#### TOWN OF WINTER PARK PLANNING COMMISSION Tuesday, February 27, 2024 8:00 AM

- a. PUBLIC HEARING: Major Site Plan 115 Discovery Drive Metes and Bounds Property
   Winter Park Resort Snowmaking System Phase II Upgrade (PLN24-010)
- b. Minor Site Plan 12, 16, 20, 24, 28, 30, 34, and 38 Wheeler Road (Building 1) and 52, 56, 60, 62, 66, and 70 Wheeler Road (Building 2) Sojourn at Idlewild Subdivision (PLN24-012 and PLN24-013)

RE PUBLIC HEARING: Major Site Plan – 115 Discovery Drive – Metes and Bounds

RE Minor Site Plan – 12, 16, 20, 24, 28, 30, 34, and 38 Wheeler Road (Building 1) and 52, 56, 60,

### **BUILDING MATERIALS BOARD**

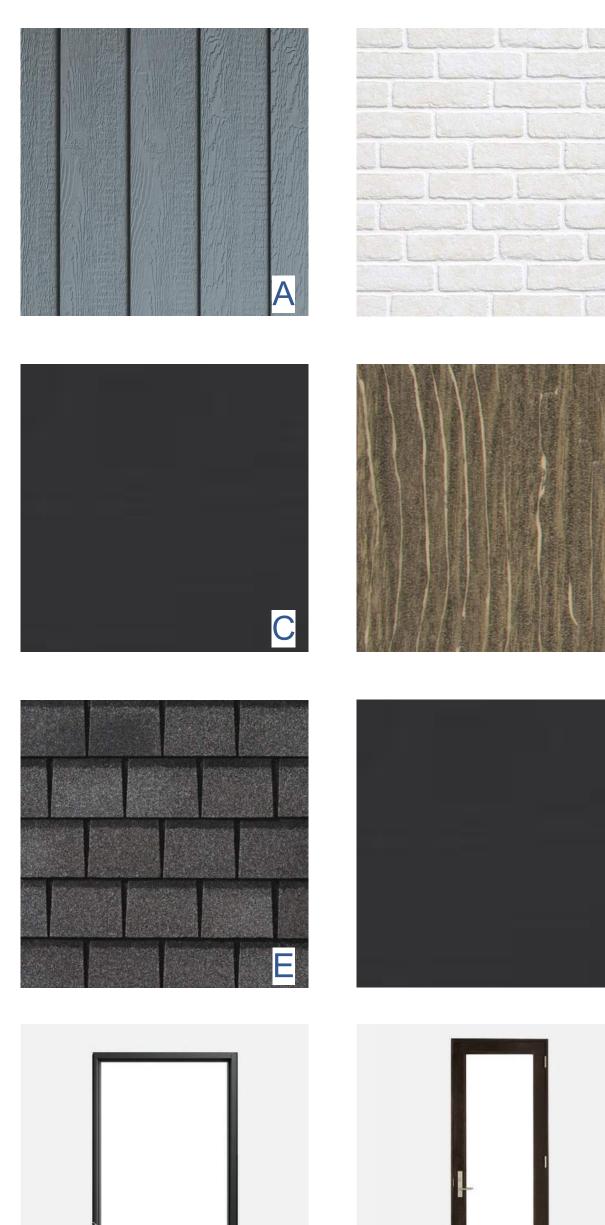
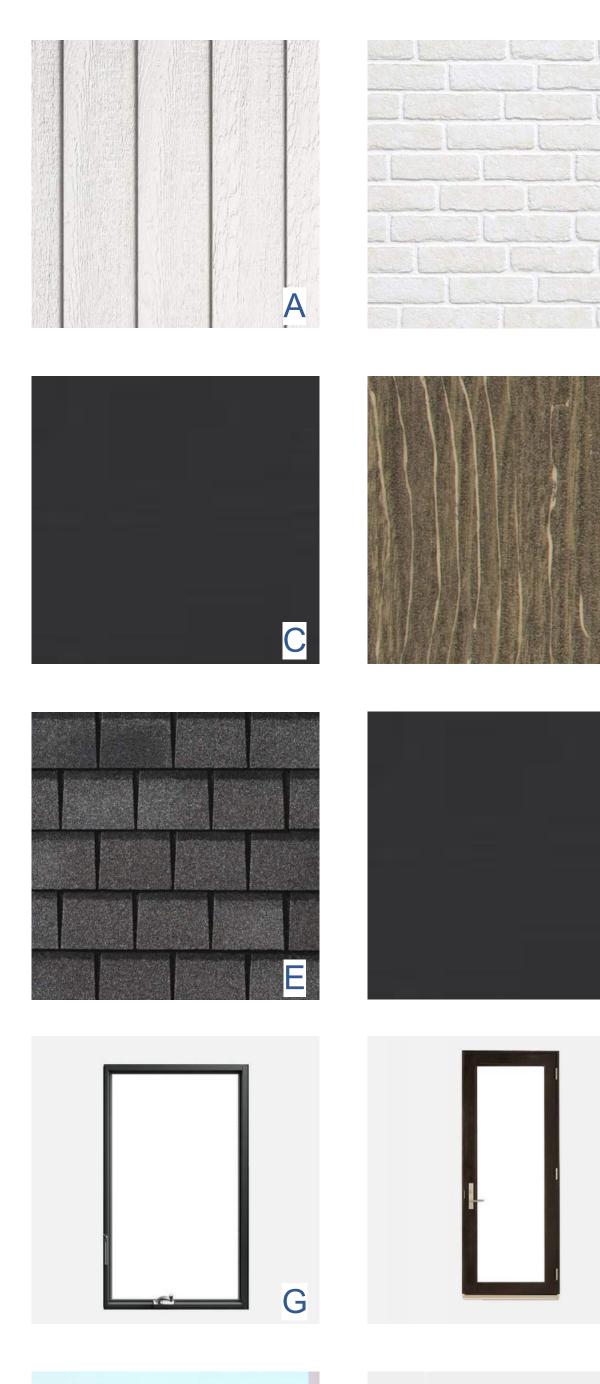
- Applicant shall indicate window glass type.
- Applicant shall clarify if the Building 2's Renderings or Material Board should be referenced for the correct proposed color of brick veneer color and shall revise whichever is incorrect.

- 1. Applicant shall indicate window glass type.
- 2. Applicant shall clarify if the Building 2's Renderings or Material Board should be referenced for the correct proposed color of brick veneer color and shall revise whichever is incorrect.

1 SITE PLAN A0.3 1/8" = 1'-0"

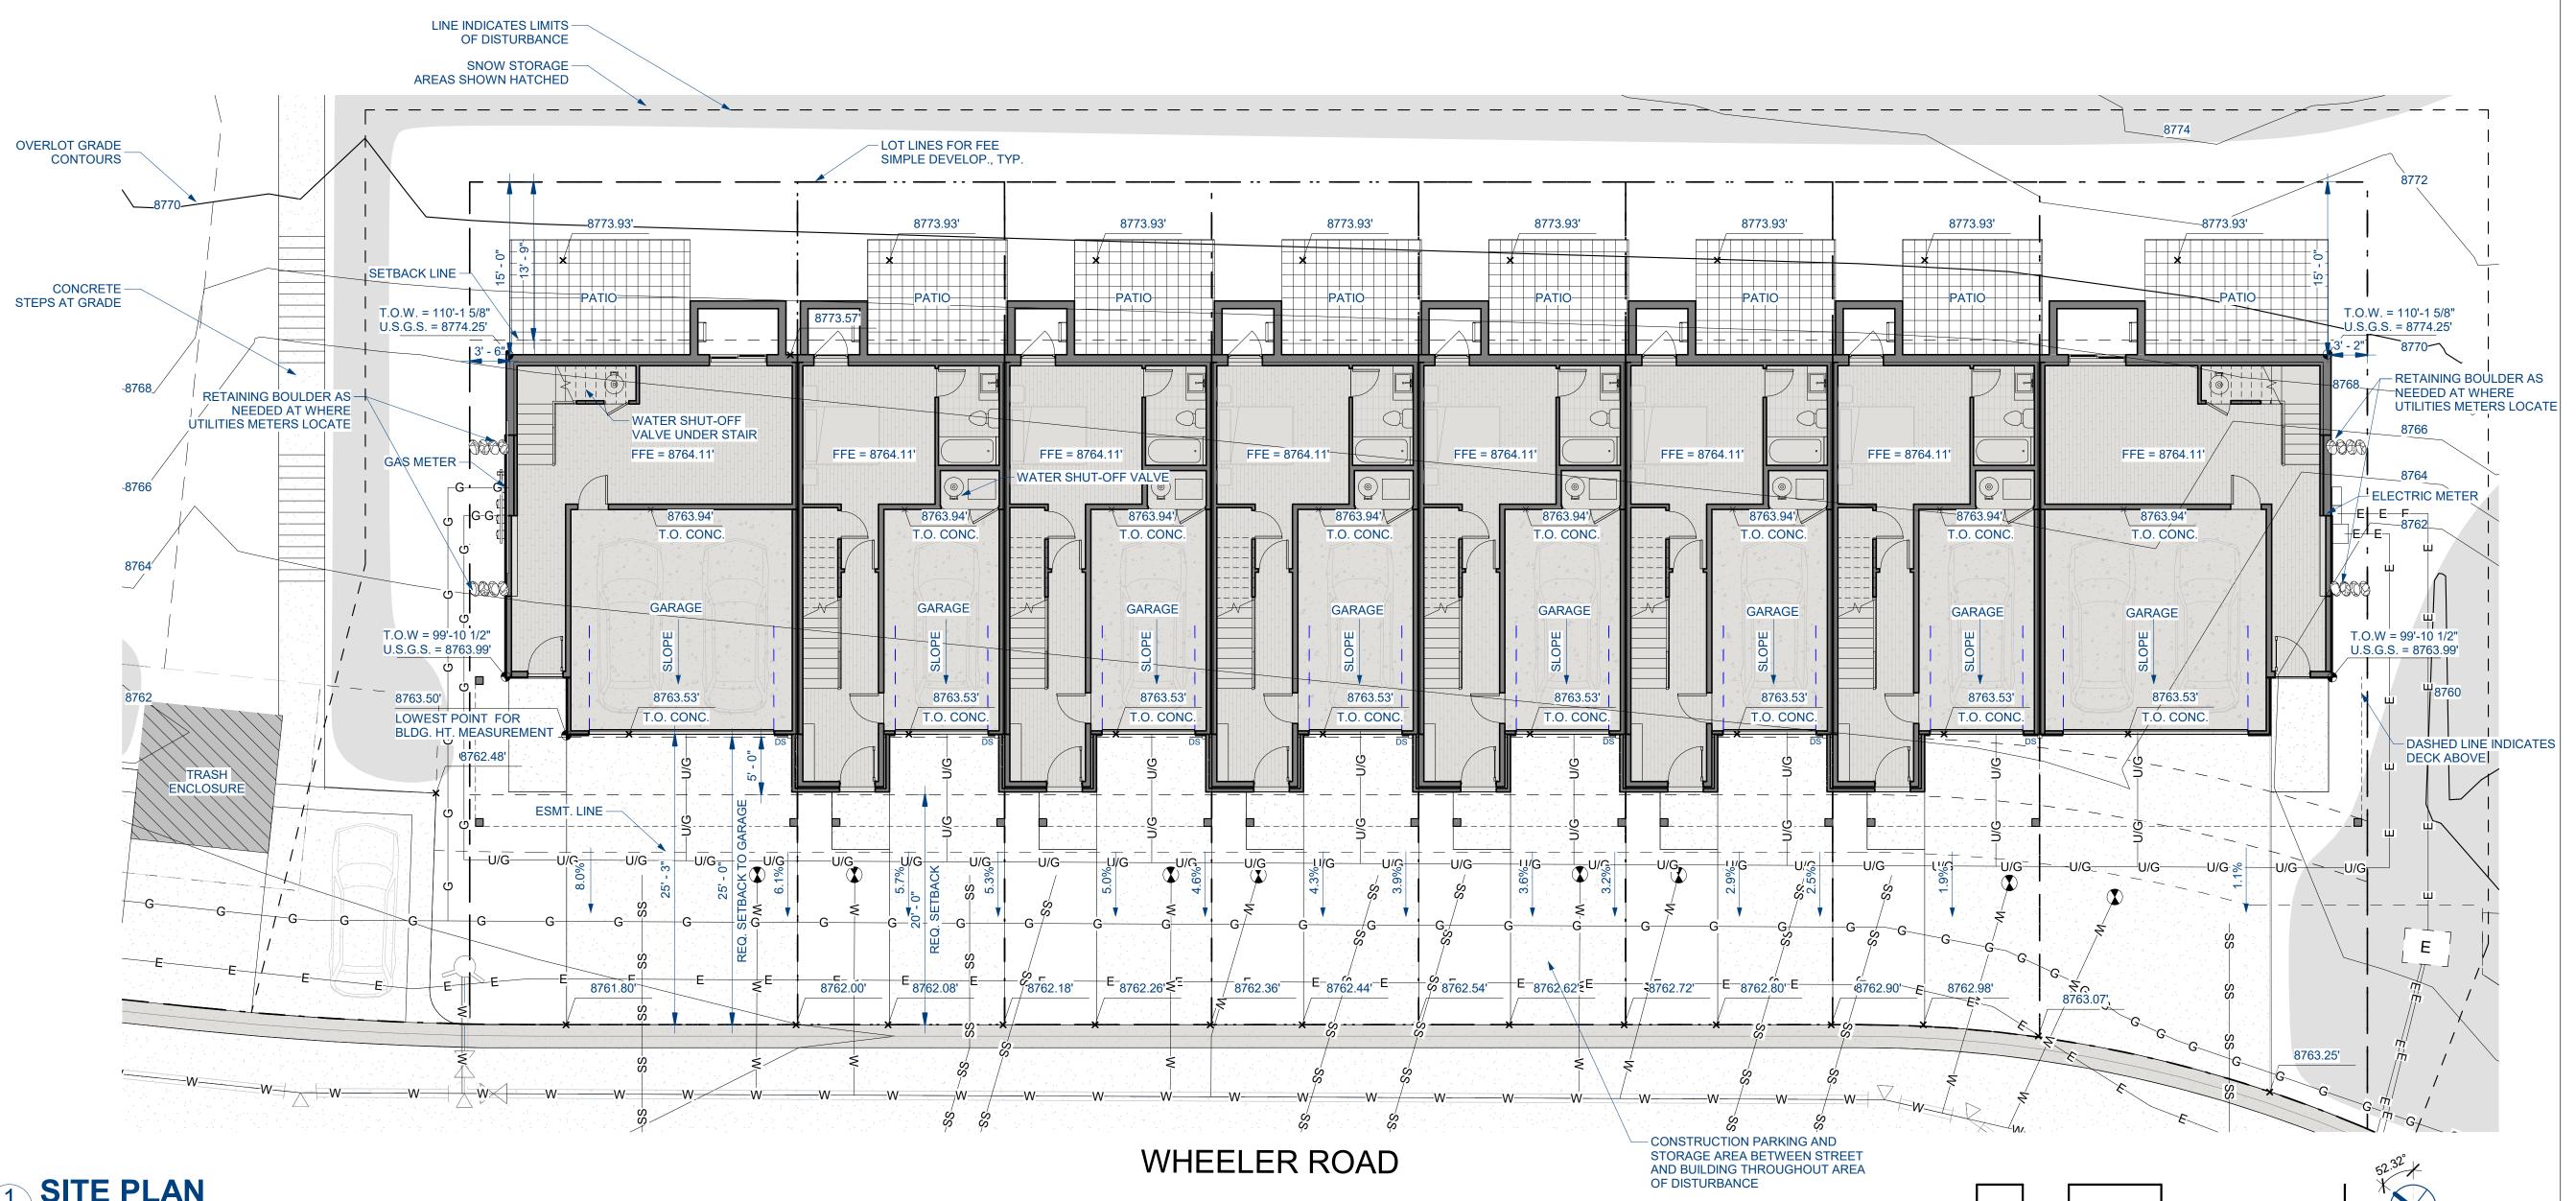
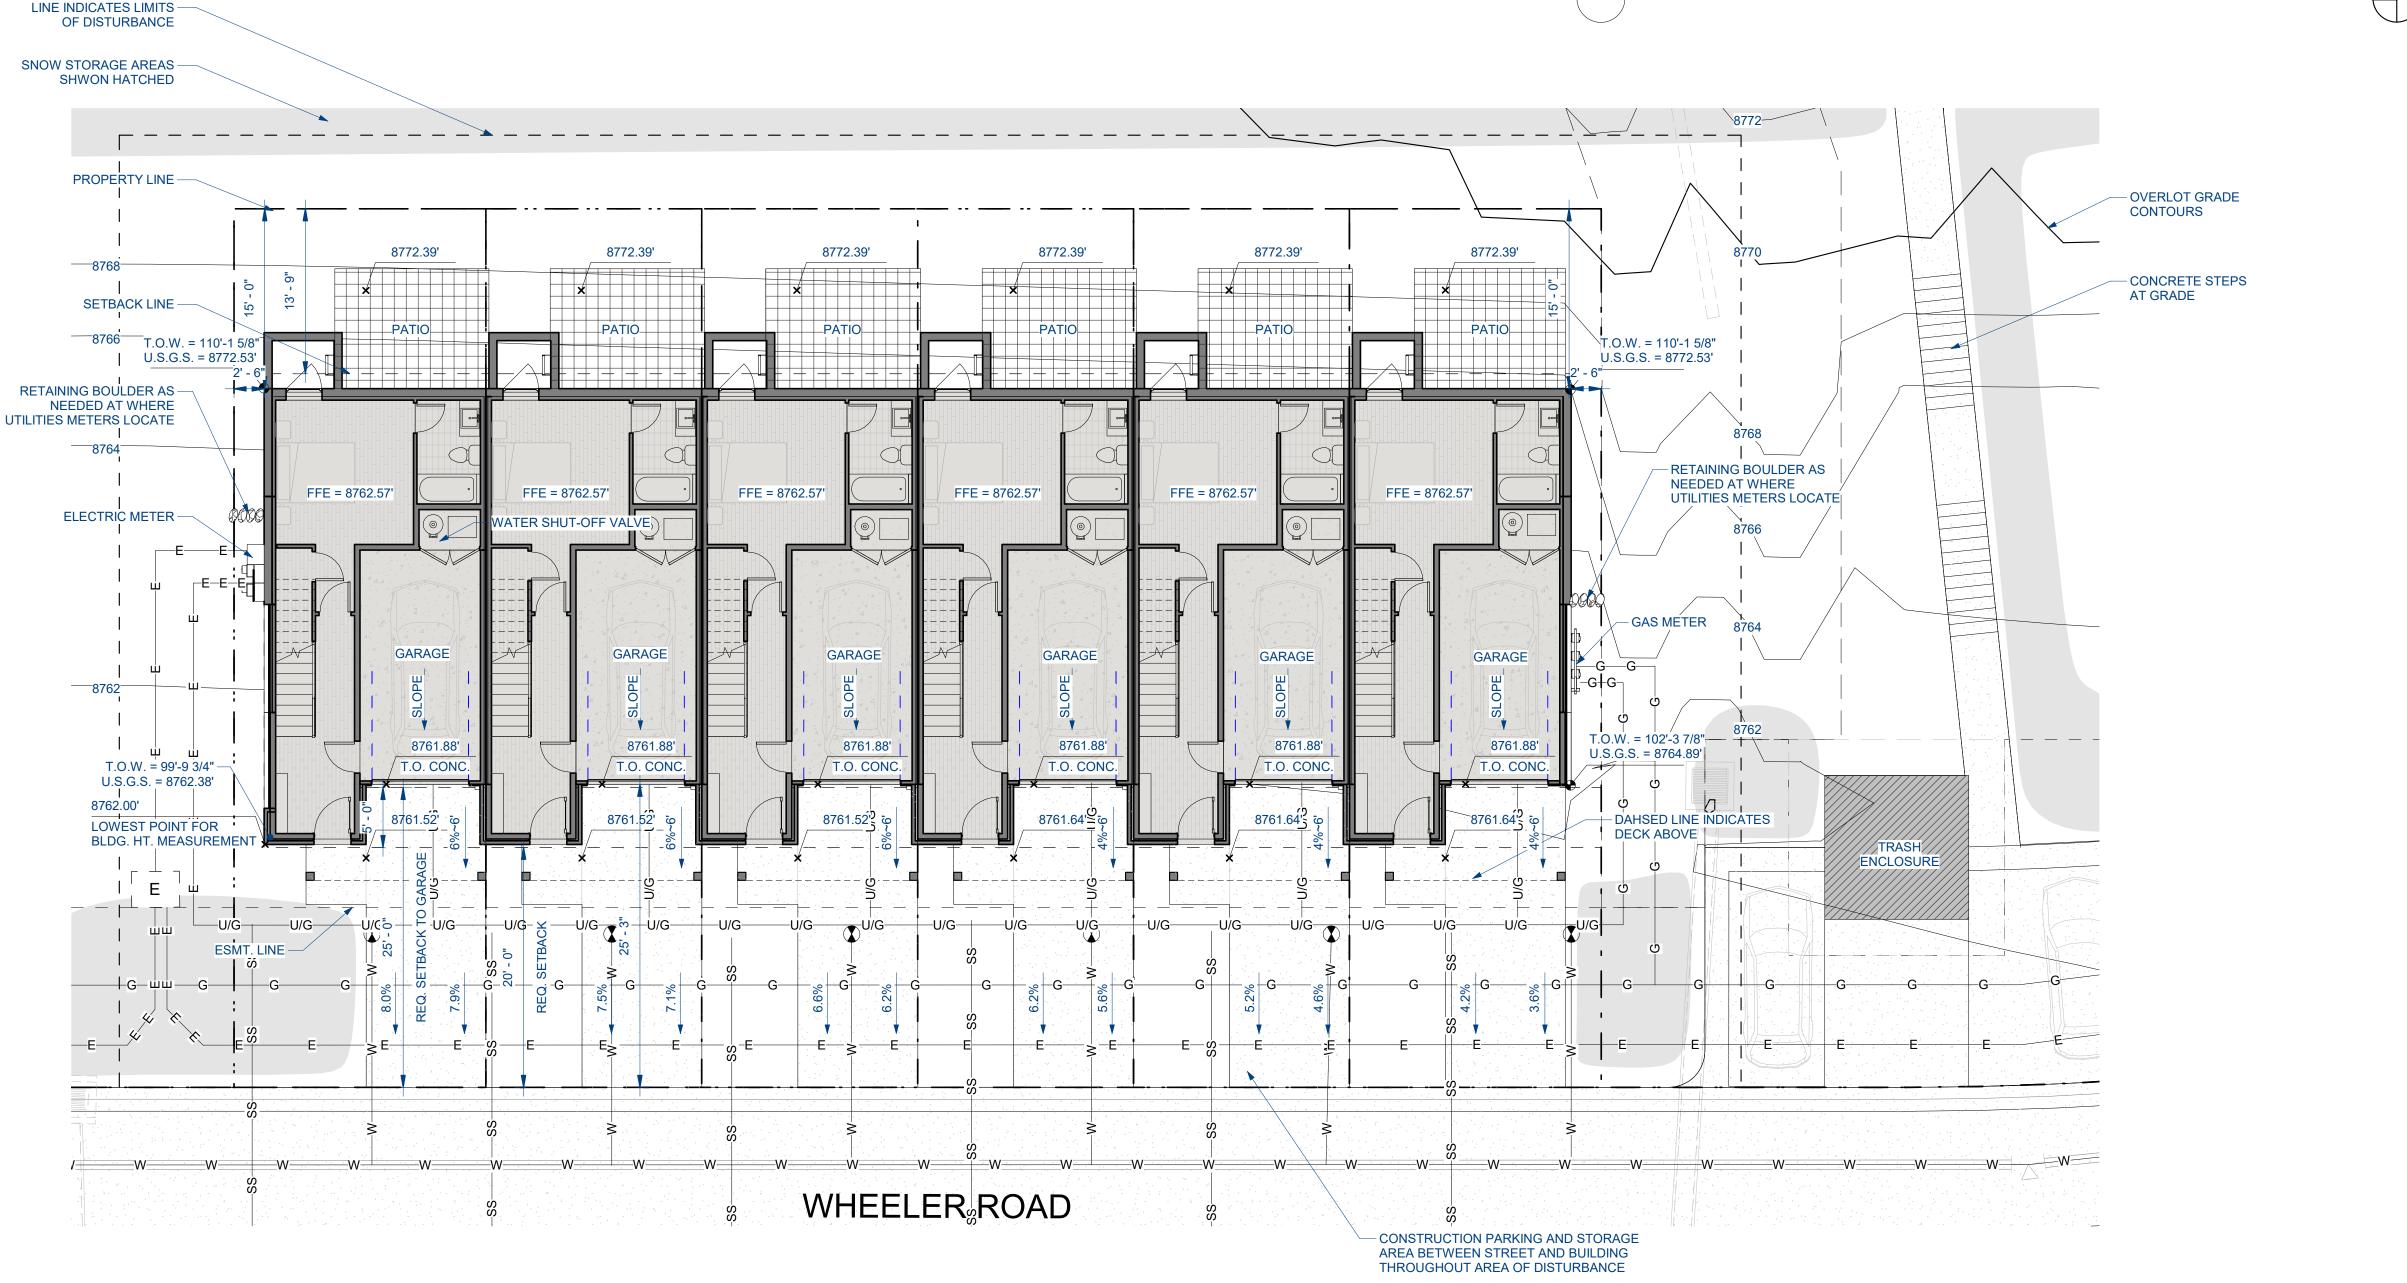
Partially satisfactory. Snow storage locations are shown on the Site Plans dated 02/13/2024 but the dimensions aren't indicated. Section 3.11 of the Standards requires that a minimum of 25% of all driving surfaces, including gravel shoulders, parking areas, and pedestrian walkways are designated for snow storage. Throughout the subdivision, these surfaces comprise 185,500 sqft. Per pg. 2 of the Plat, at least 46,375 sqft of snow storage are required for the subdivision, and 48,525 sqft are proposed. A 15' easement for snow storage (and utilities and drainage) is provided at the front of all lots on the north side of Wheeler Road.

- 7. Dimensions of snow storage areas shall be indicated on the Site Plan exhibits.
- 8. Should the Town Engineer have comments, Applicant shall revise Grading and Drainage Plan accordingly.
